QUAIL BRUSH GENERATION
PROJECT

DOCKET NO. 11-AFC-03

STATUS REPORT INTERVENOR:

Kevin C. Brewster

Save Mission Trails' visual simulation of the project.

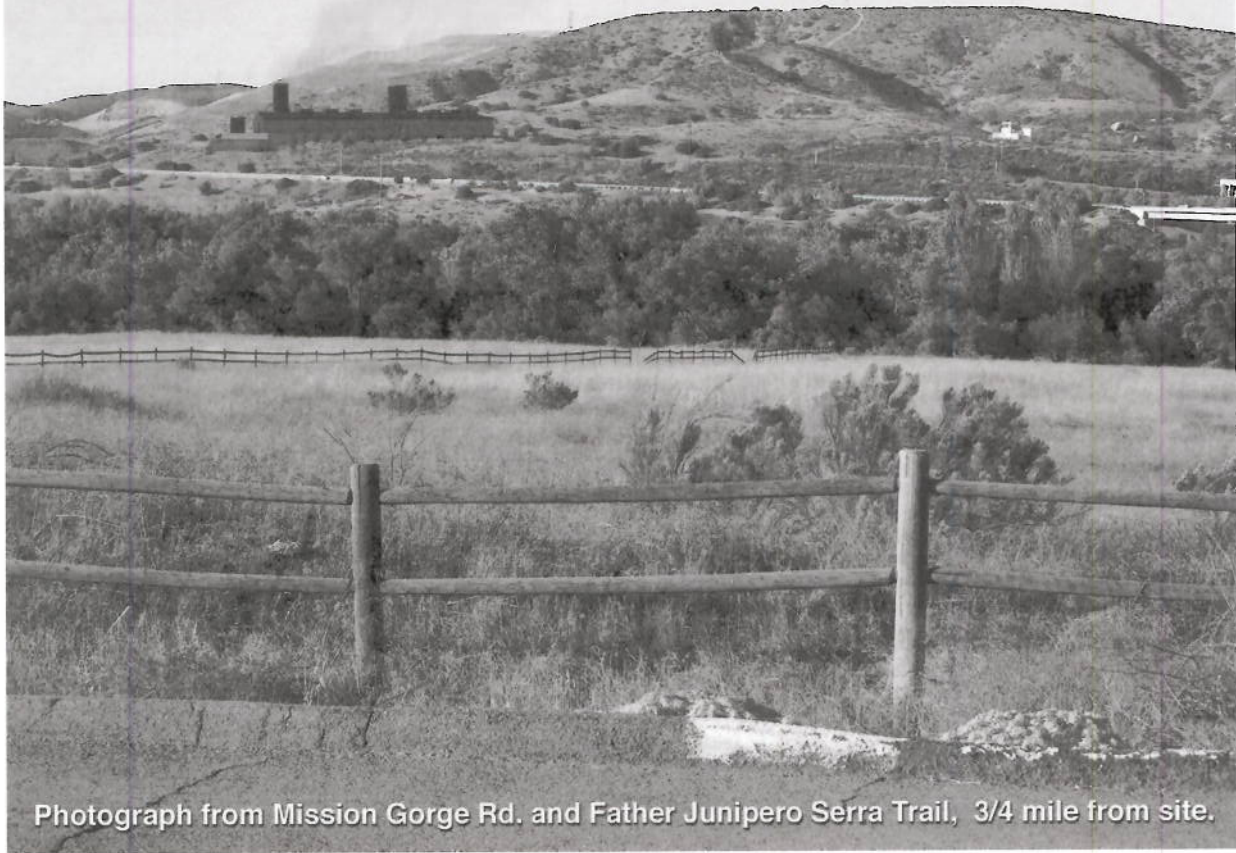
Solar would not endanger the navigation of Military and Civilian pilots with Thermal plumes

Solar would not disturb the cultural landscape of Native American and Spanish settlers.

Solar would not deface the largest urban park in the United States.
